## **Planned Change Request for Shielded Containers**

### **Summary**

Figure 1

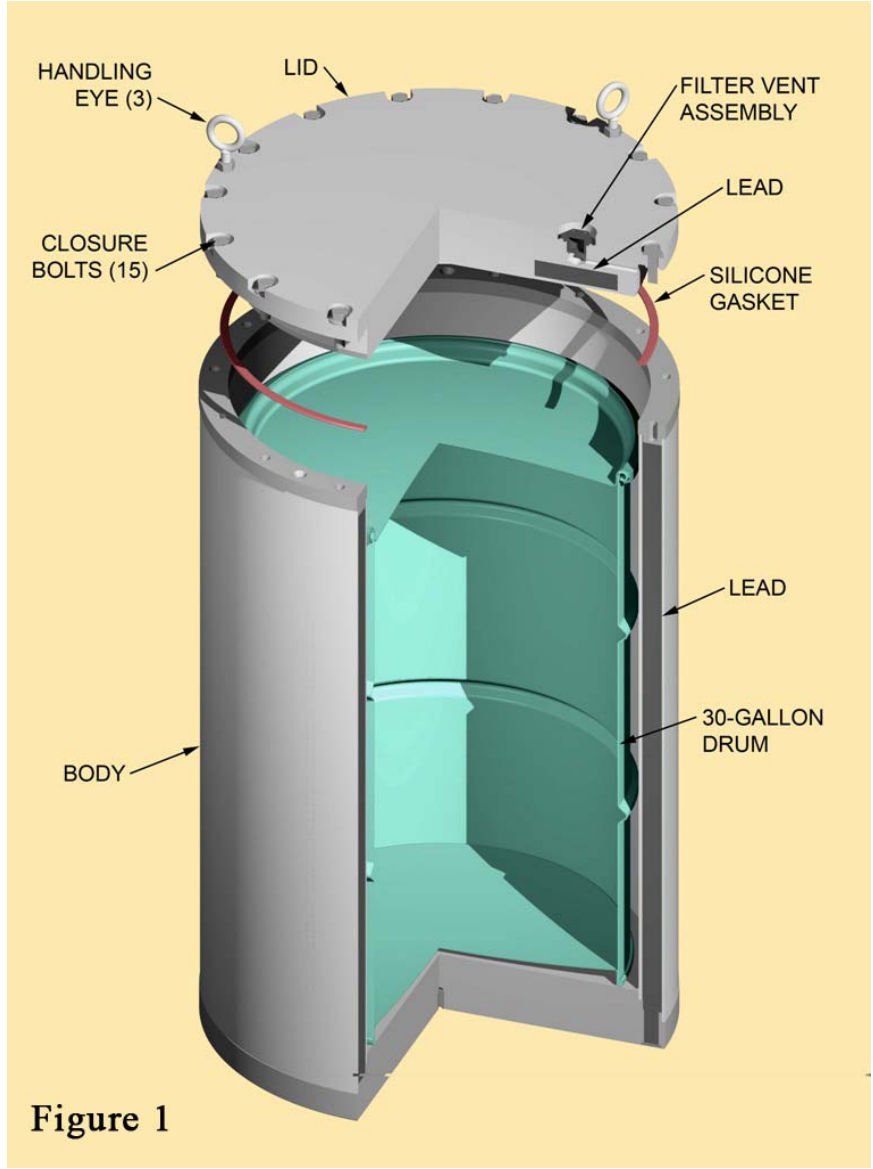
The shielded container has approximately the same exterior dimensions as a 55-gallon drum and is designed to hold a 30-gallon drum. The cylindrical sidewall of the shielded container has 1-inch thick lead shielding sandwiched between a double-walled steel shell as shown in Figure 1. The external wall is 1/8 inch thick, and the internal wall has a thickness of 3/16 inch. The lid and the bottom of the container are made of carbon steel and are 3-in thick. The empty weight of the containers is approximately 1,800 pounds. The shielded container and the inner 30-gallon drum will be vented. The container has been tested to DOT Type 7A and NRC Type B Hypothetical Accident Conditions (HAC) specifications. This will ensure the container is safe for transport and handling and will contain and shield the waste under the most severe accident conditions.

Figure 2

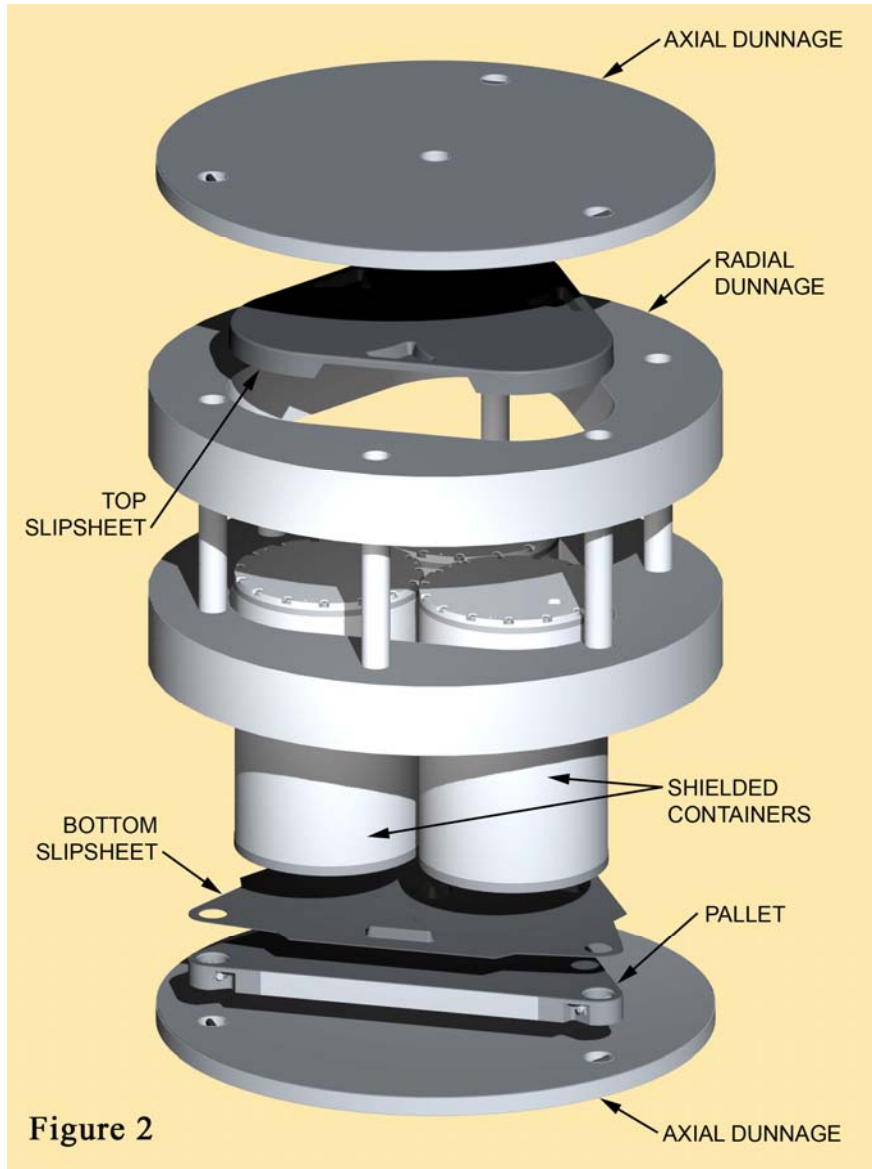
The shielded containers will be assembled in a 3-pack configuration on a triangular pallet, be surrounded by radial and axial dunnage components, and be transported within the existing HalfPACT transportation container. The 3-pack configuration will remain intact throughout transportation and emplacement (Figure 2). The shielded container is designed to stay within the parameters of the HalfPACT design and licensing bases e.g., payload weight, decay heat and radiation dose rate limits. To ensure the robustness of the container, it was subjected to DOT 7A Type A testing that included 4 foot drops of the bare container onto an unyielding surface using four potentially worse-case orientations. As part of the safety analysis, a 3-pack of containers was drop tested 30-feet inside a HalfPACT ICV (Inner Containment Vessel) as part of the Hypothetical Accident Condition (HAC) evaluation required by Title 10 CFR Part 71. The HAC tests evaluate and ensure the containers will adequately shield the RH TRU waste contained within under the most severe accident conditions. The thermal, shielding and criticality evaluations were performed by analysis using similar methodology as presented in the HalfPACT Safety Analysis Report (SAR), RH-TRU 72-B SAR and the TRUPACT II SAR. The tests were successful and the results will be used to demonstrate compliance with all applicable DOT and NRC standards, ultimately leading to certification of the payload container as a DOT 7A, Type A container and as an authorized payload container for shipment within the NRC certified HalfPACT Type B Packaging. DOE is awaiting regulatory approval. The success of this testing proved the container is safe even after being subjected to worst case severe handling or accident condition impacts as specified within the DOT and NRC regulations.
